STATE SIGNIFICANT DEVELOPMENT ASSESSMENT

ACCESSIBILITY REPORT

Project: 2A Llewellyn Street, Rhodes NSW 2138
Document Type: State Significant Development Assessment
Our Reference: P2024_2807-3 (SSDA) YW & DC

Figure 4 – Proposed principal pedestrian access routes from Llewellyn St

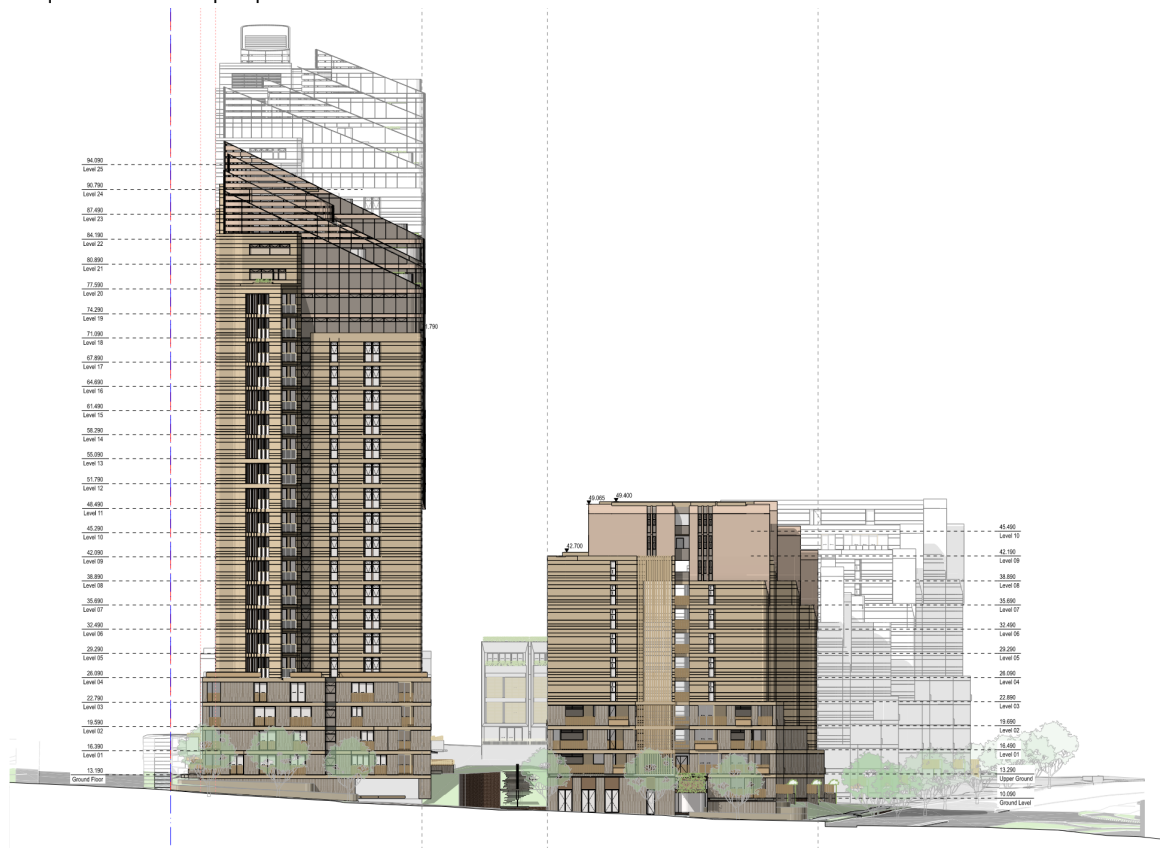
Given the substantial size of the site, the travel distance between all pedestrian site entries exceeds 50 metres. Therefore, all paths of travel must be fully accessible in accordance with relevant standards.

The information provided is considered adequate for the purposes of the SSDA.

3.2.8 Clause D4D9 – Tactile indicators

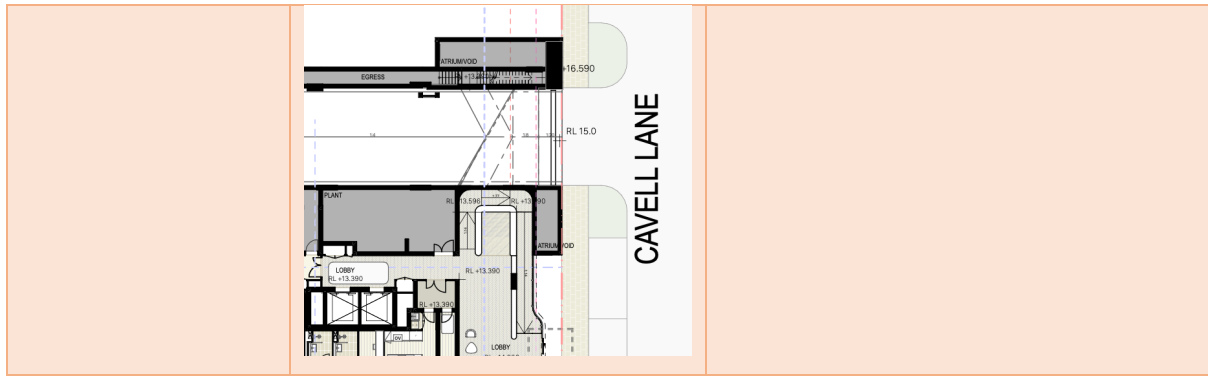
The provision of tactile indicators is not yet documented on the SSDA plans; further details are to be finalised as the as the design progresses to the Building Approval stage.

DESCRIPTION	COMPLIANCE DEPARTURE	RESOLUTION
Northeast building entrance ramp	Tactiles indicators are required at the handrails of the ramp. Alternatively, where spatial limitations are a concern, a Performance Solution may be	A performance solution may be considered for the installation of a domed button. Other alternatives may also be considered in lieu of tactile indicators for Universal Design and

considered by installing domed buttons on the handrail extension in lieu of tactile ground surface indicators. This approach may be appropriate given the provision of 100% Livable Housing, where tactile indicators could pose a trip hazard for the ageing population and, in some cases, may also be considered an aesthetic concern.	aesthetic purposes, such as the use of braille on handrails to identify destinations as a performance-based solution.
Northeast building entrance stairway	Tactile indicators are required at the handrails of the stairway.	A performance solution may be considered for the installation of a domed button. This approach may be appropriate given the provision of 100% Livable Housing, where tactile indicators could pose a trip hazard for the ageing population and, in some cases, may also be considered an aesthetic concern.
Llewellyn Street and Cavell Lane vehicular access - Warning tactile indicators	Warning tactile indicators are also required where a pedestrian accessway intersects with vehicular access, such as waste collection vehicles routes or basement parking access, particularly where the pedestrian path and carriageway appear to be at the same level. 	As the design progresses, warning tactile indicators should be documented in the Building Approval documentation.

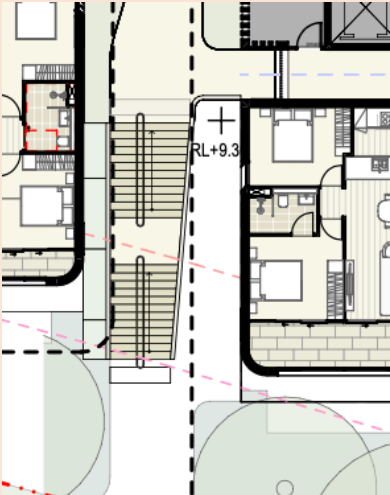
Twelve (12) passenger lifts are proposed to serve the residential component of the development. The southwest and east towers are each proposed to be serviced by three (3) lifts, while the remaining buildings will be provided with two (2) lifts each.

DESCRIPTION	COMPLIANCE DEPARTURE	RESOLUTION
A platform lift may be required between South-East Concord and East Concord	Due to a significant level difference along the south-eastern allotment boundary of the development site, particularly between South-East Concord and East Concord, where a stairway is currently proposed a platform lift will be required. This will be delivered as a performance solution, as permitted under the National Construction Code (NCC) where Deemed-to-Satisfy provisions are limited. 	A suitable lift access performance solution will be developed as the design progresses.

As the design progresses to the Construction Certificate stage, lift shop drawings must be submitted for review prior to the final Building Approval. Please refer to Appendix 2 for further design guidance and lift specifications.
